## Product / Process Change Notification (PCN)

**PCN #:** PCN\_IndSL5HC\_20210929

**Affected Series:** WE-SL5HC; 744273xxx

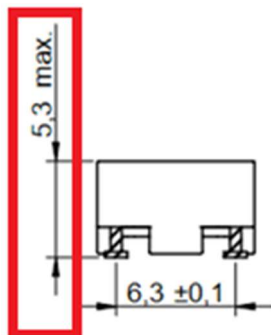
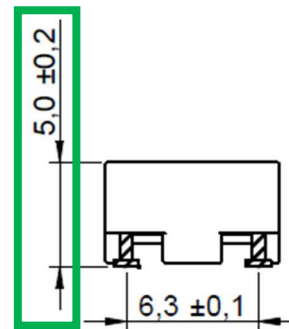
Due to an improvement of the production capability, Würth Elektronik will adjust the height tolerance of the components.

#### Before

Height dimension: 5.3 mm (max)

#### After

Height dimension: 5.0 mm +/- 0.2
